# Notice of Alteration Form

Reference: Notice of Alteration Report

Domestic Wastewater lagoon Municipality of Armstrong, MB

# **Notice of Alteration Report**

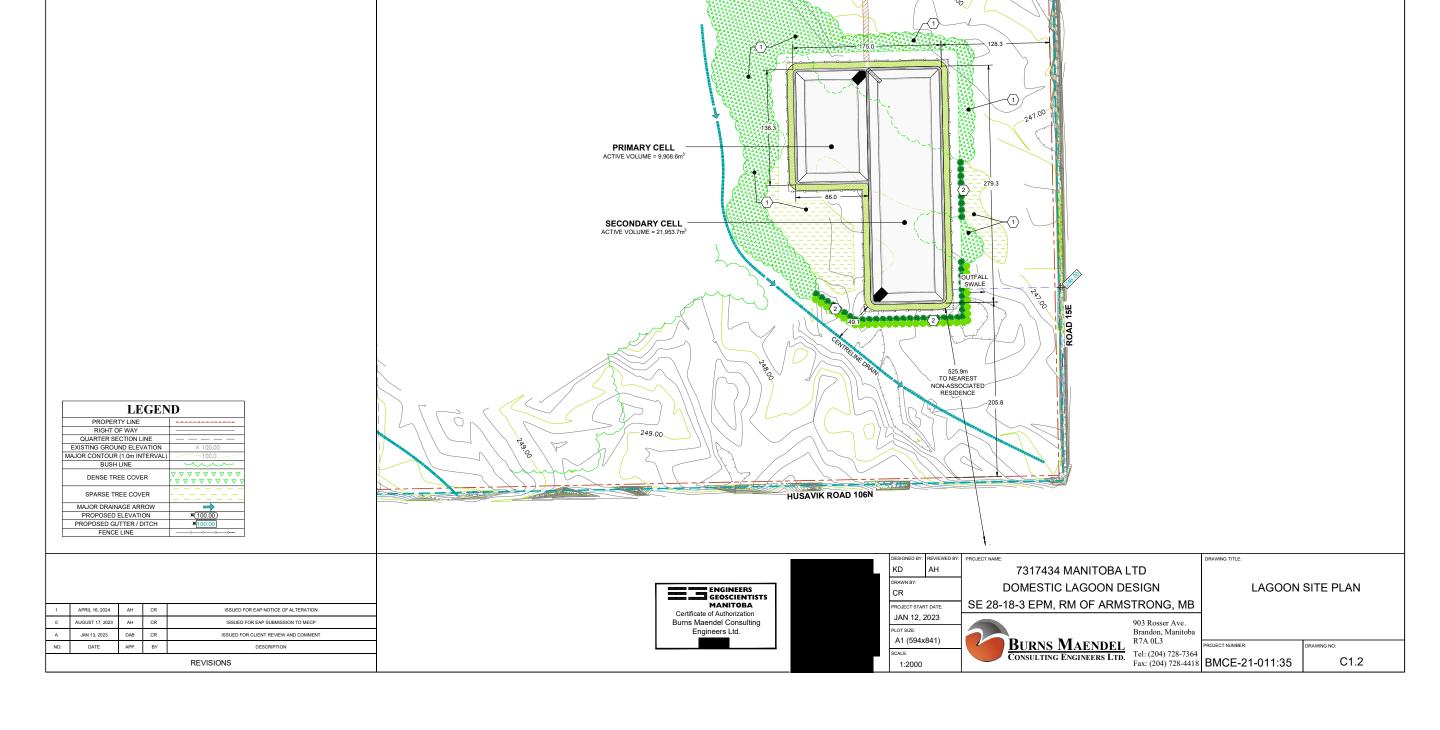
- 1 TREED BUFFER TO BE MAINTAINED.
- ADDITIONAL TREES TO BE PLANTED TO CREATE CONTINUOUS BUFFER OF TREES.
  - MINIMUM TWO ROWS OF TREES REQUIRED WHERE NO TREES CURRENTLY EXIST, AS SHOWN.
  - MINIMUM ONE ROW OF TREES REQUIRED WITHIN THE SPARSELY TREE COVERED AREA, AS SHOWN.
